MFN 06-274

Subject: Response to RAI Letter Number 20 Related to ESBWR Design Certification Application – Seismic Design – RAI Numbers 3.7-16, 3.7-24, 3.7-27, 3.7-30, 3.7-32, 3.7-33, 3.7-35, 3.7-37, 3.7-38, 3.7-39, 3.7-50, 3.7-54 and 3.7-57

**Response to NRC RAI Letter No. 20 Related to ESBWR Design
Certification Application**

Shimizu Engineering Report																	
Project	General Electric Company ESBWR Project		Shimizu Document No.	SER-ESB-033													
Title	Parametric Evaluation of Effects on SSI Response		Rev.	0													
			Issued Date	8/14/06													
			Revised Date														
<p>NOTE:</p> <p>This document provides additional SSI analyses performed and results obtained for the Reactor/Fuel Building Complex (RBFB) the Control Building (CB) to address the following issues identified in RAIs.</p>

Figure 7.5-11 Floor Response Spectra - RSW Top Y

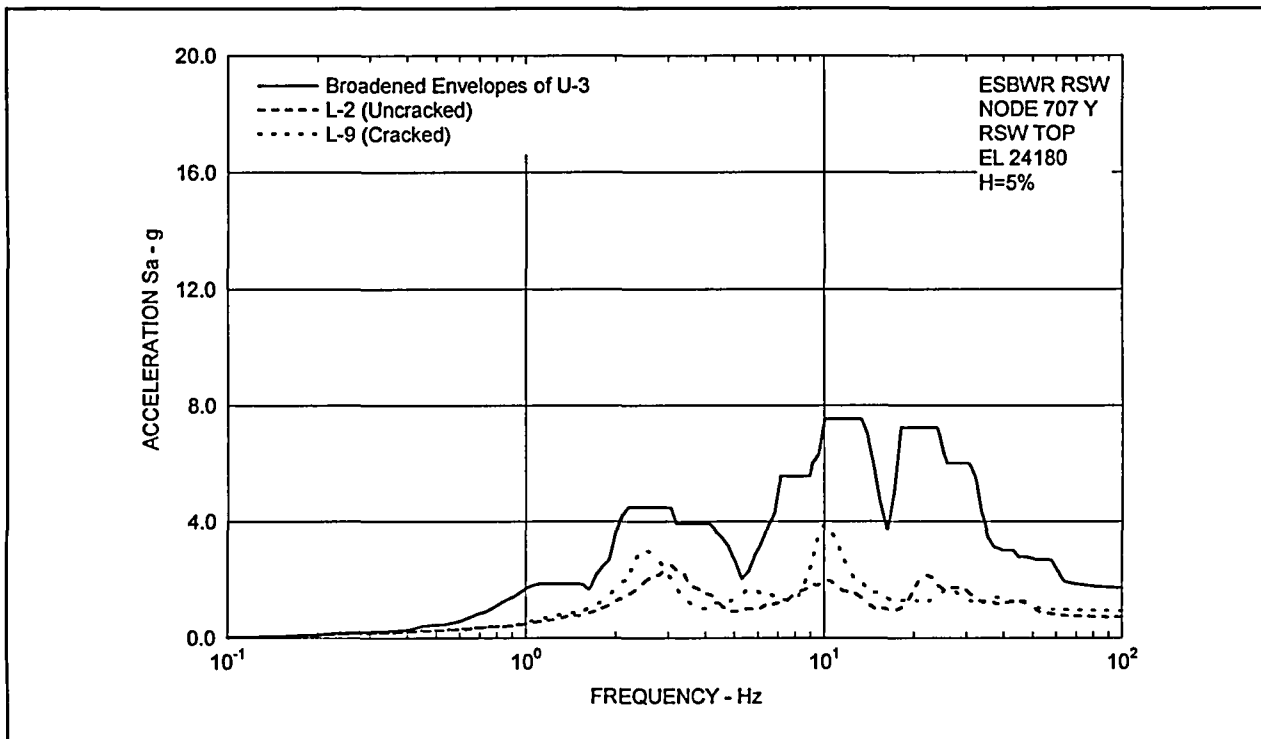
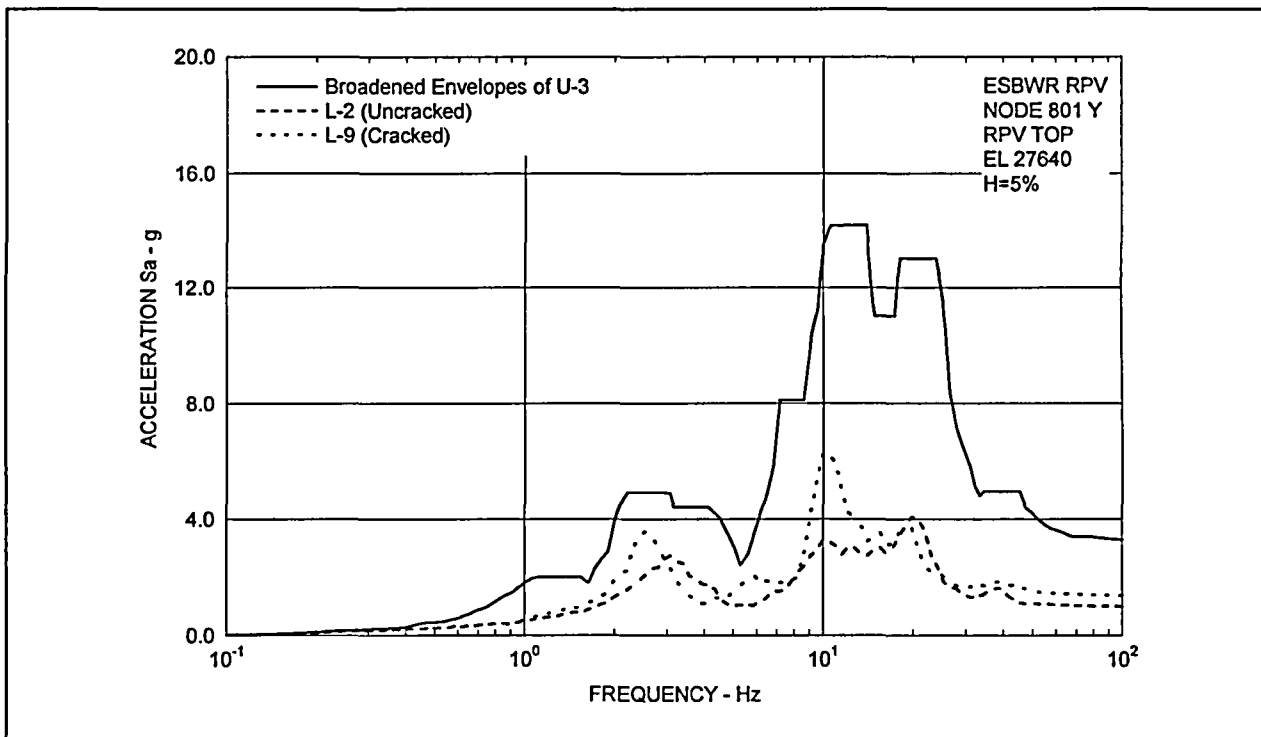
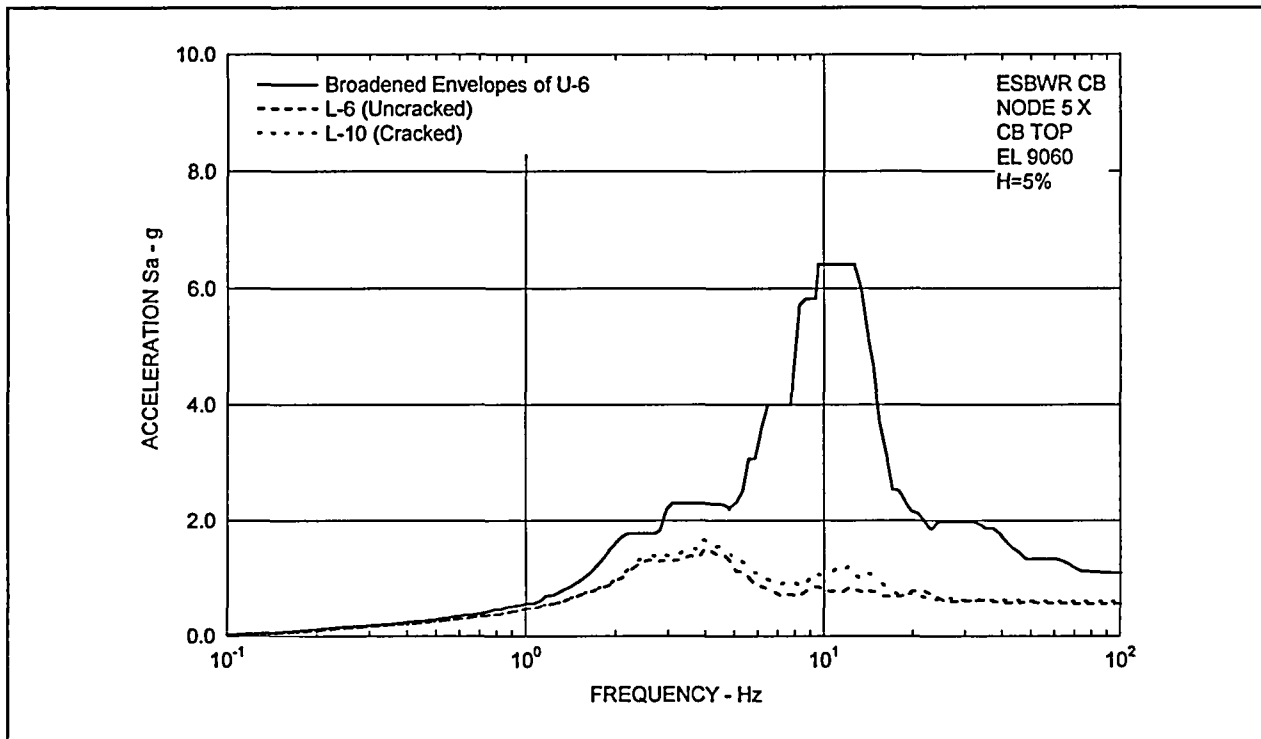
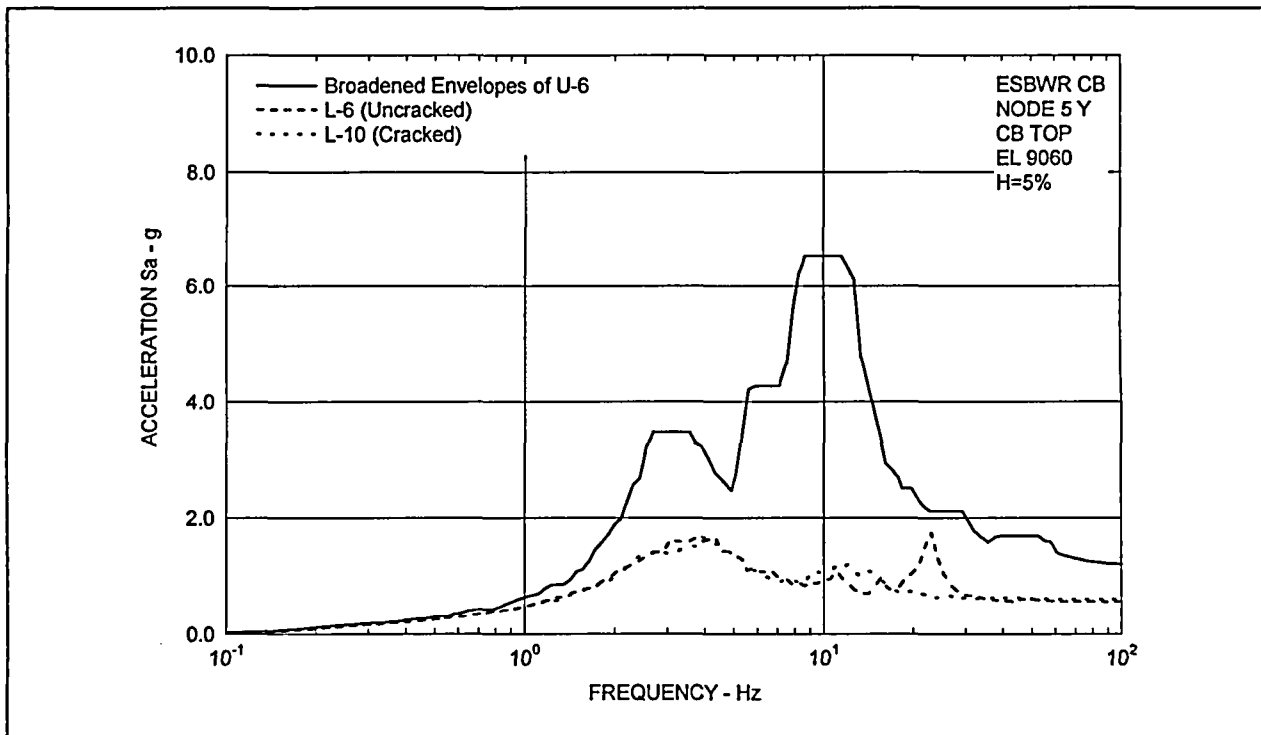
DCD Section 3.7.2.3, "Procedures Used for Analytical Modeling," does not address the method used to develop stiffness values (uncracked concrete sections versus cracked concrete sections) for concrete structural elements for the seismic analysis models. The staff requests the applicant include in the DCD a detailed description of the method applied to determine the stiffness values for both cracked concrete sections and uncracked concrete sections in the seismic analysis models.

Comparisons of floor response spectra (FRS) (5% damping) at selected RBFB locations are shown in Figures 7.5-1 through 7.5-12. The broadened envelope results of Case U-3 (uniform site, single envelope input motion case) are also shown in the figures for comparison.

It is found from the results that the FRS peaks move to lower frequencies by concrete cracking; however, both FRSs of uncracked and cracked cases are bounded by the broadened envelope responses of uniform site cases in the whole frequency range.

As stated in Section 7.1, the existing DCD design load will be updated to incorporate the responses due to the single envelope input motion at the uniform sites. The revised DCD design load has no impact from the effect of concrete cracking.

7.6 Effect of Structure-to-Structure Interaction – RAI 3.7-39

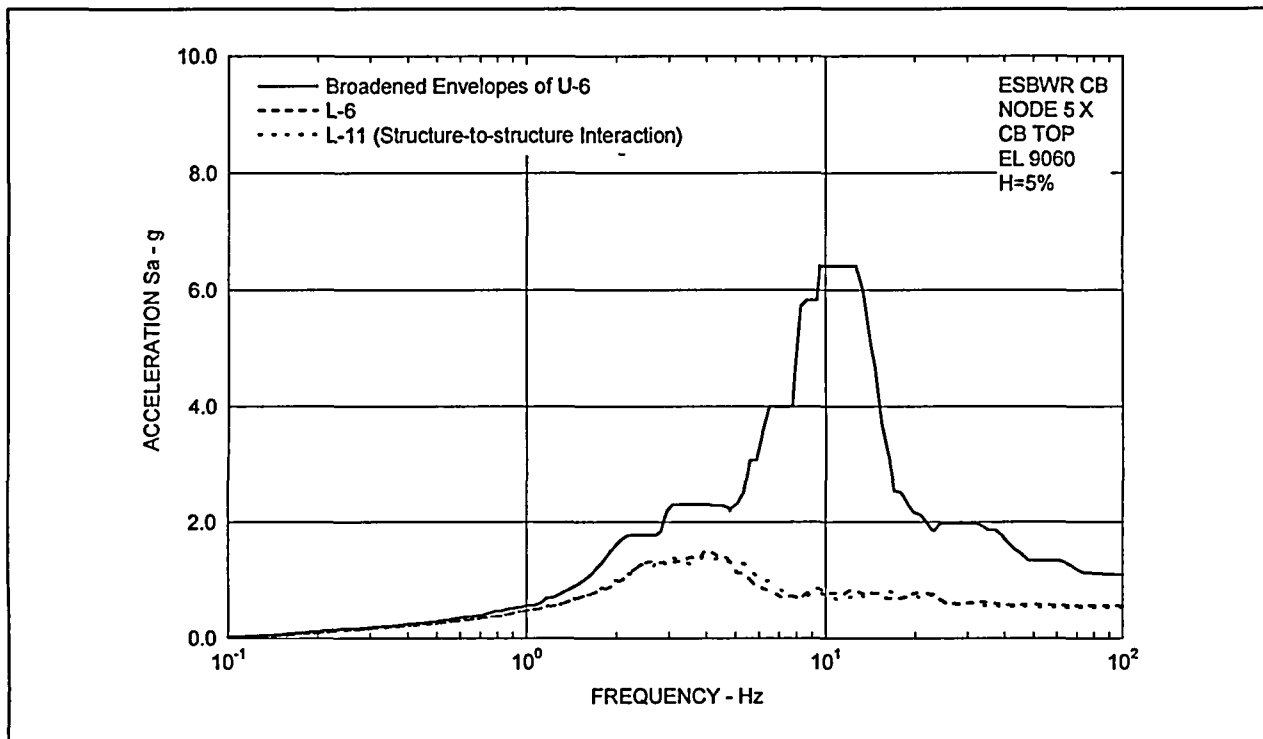
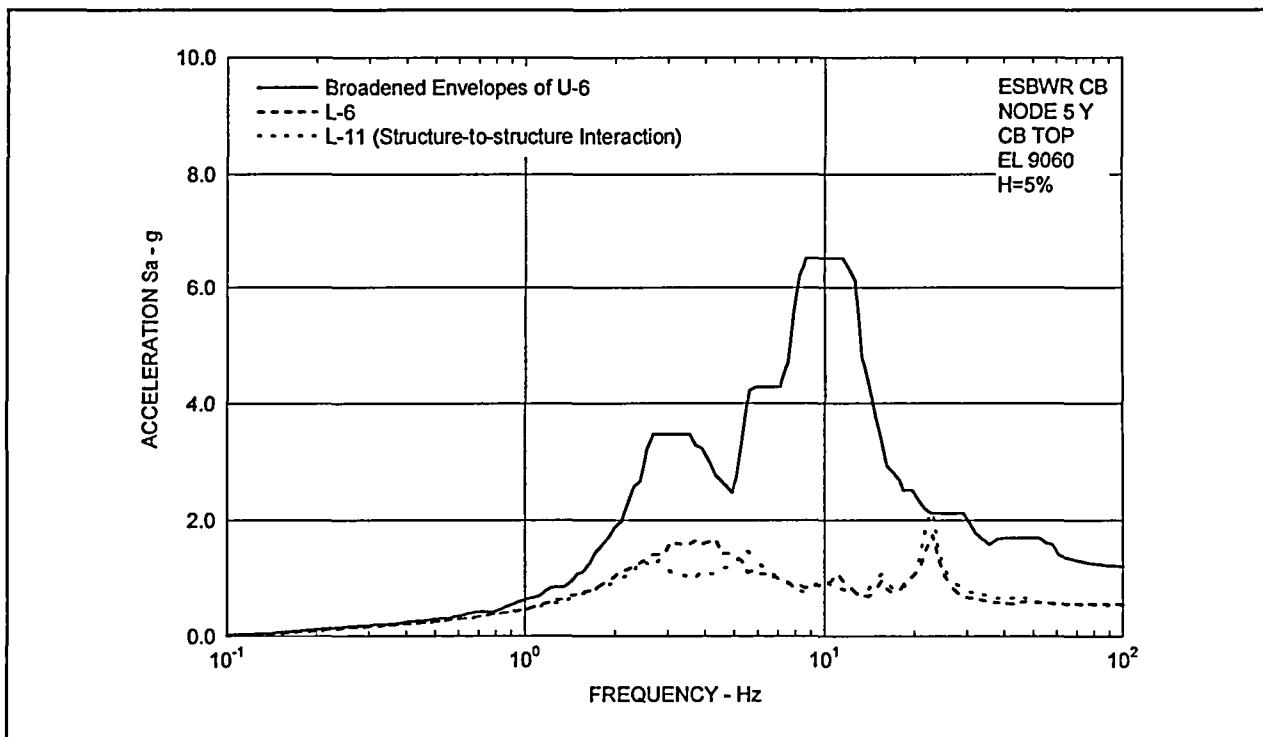
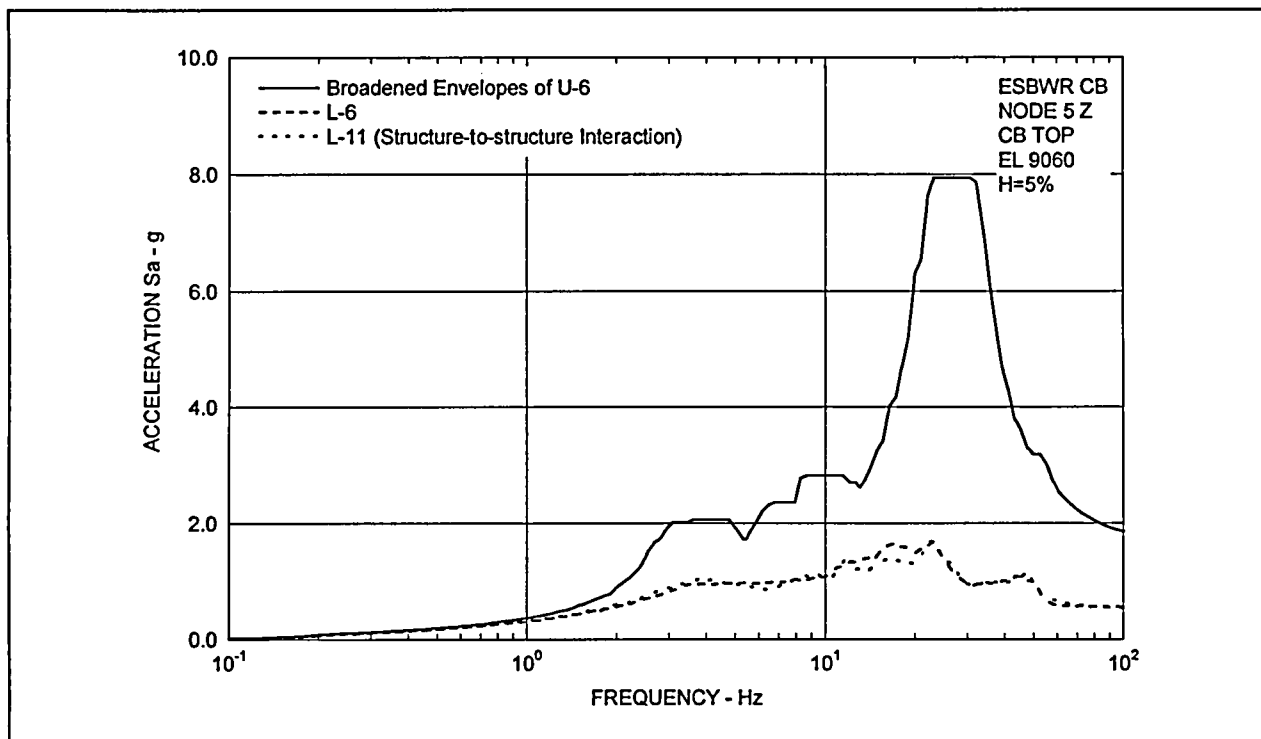
For the SSI analyses that were performed, the staff requests the applicant to describe in detail in the DCD how it considered the effect of structure-to-structure interaction through the soil between the RB/FB and CB. The staff considers this a potentially significant effect, especially for the response of the CB.

Comparisons of floor response spectra (FRS) (5% damping) at the top of CB are shown in Figures 7.6-1 through 7.6-3. The broadened envelope results of Case U-6 (uniform site, single envelope input motion case) are also shown in the figures for comparison.

It is found from the results that the effect of structure-to-structure interaction is the largest in the Y direction (East-West) FRSs, however, both FRSs without and with structure-to-structure interaction effect are bounded by the broadened envelope responses of uniform site cases in the whole frequency range.

As stated in Section 7.1, the existing DCD design load will be updated to incorporate the responses due to the single envelope input motion at the uniform sites. The revised DCD design load has no impact from the effect of structure-to-structure interaction.
